IN THE DRAWINGS

ANNOTATED SHEET SHOWING CHANGES

FIG.1

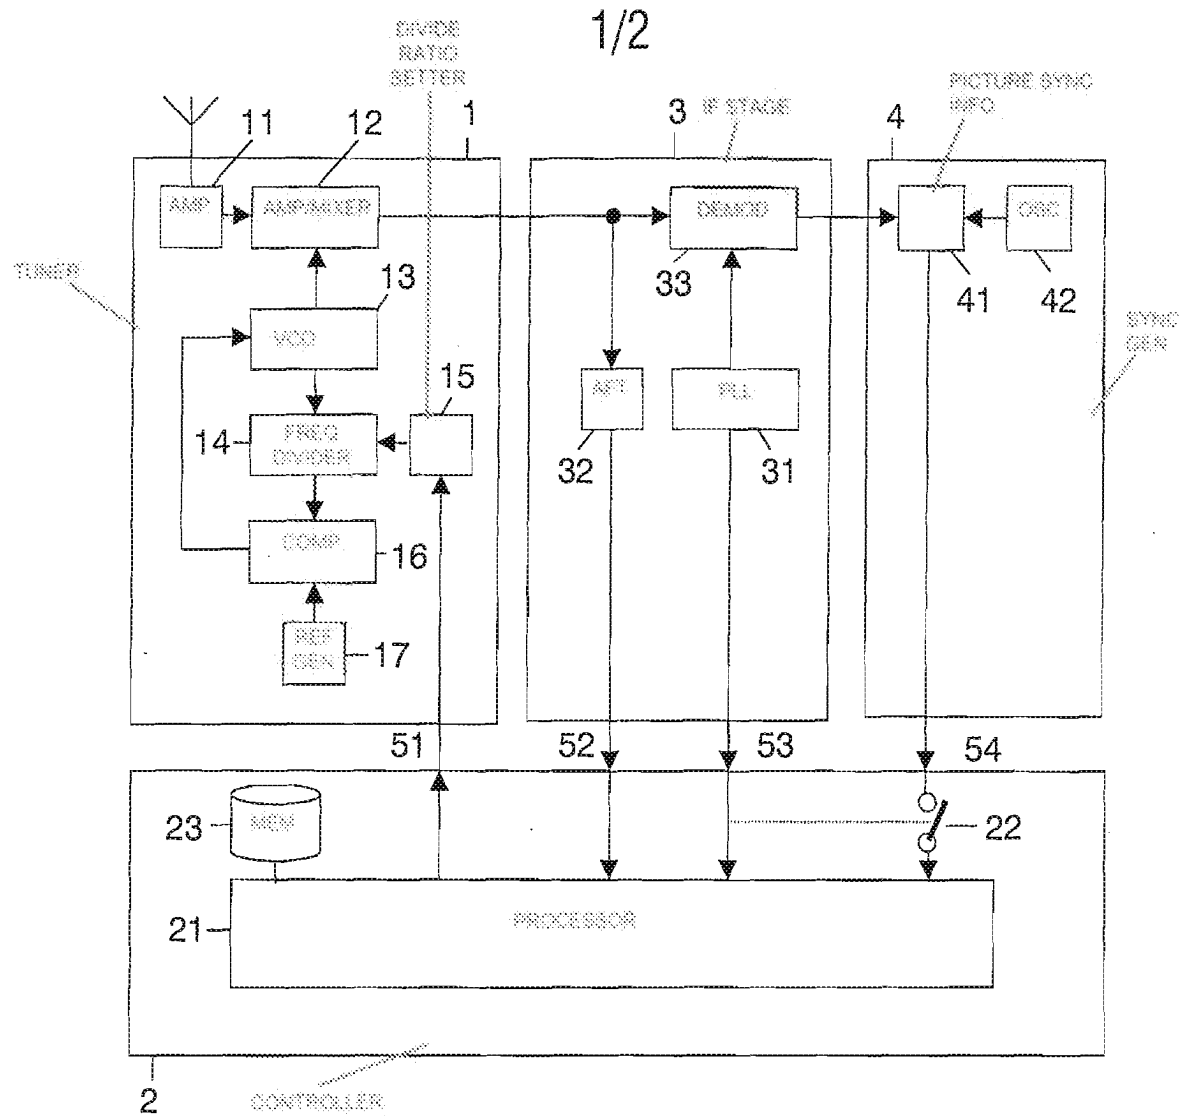
Applicants propose to label the blocks in Figs. 1-3 and to revise Fig. 1 in accordance with the accompanying ANNOTATED SHEETS SHOWING CHANGES.

The Examiner has objected to the drawing in that the added arrow from the top of AFT 32 over to the top of PLL 31 is New Matter. Enclosed herewith are new ANNOTATED SHEETS SHOWING CHANGES and REPLACEMENT SHEETS in which said arrow has been eliminated.
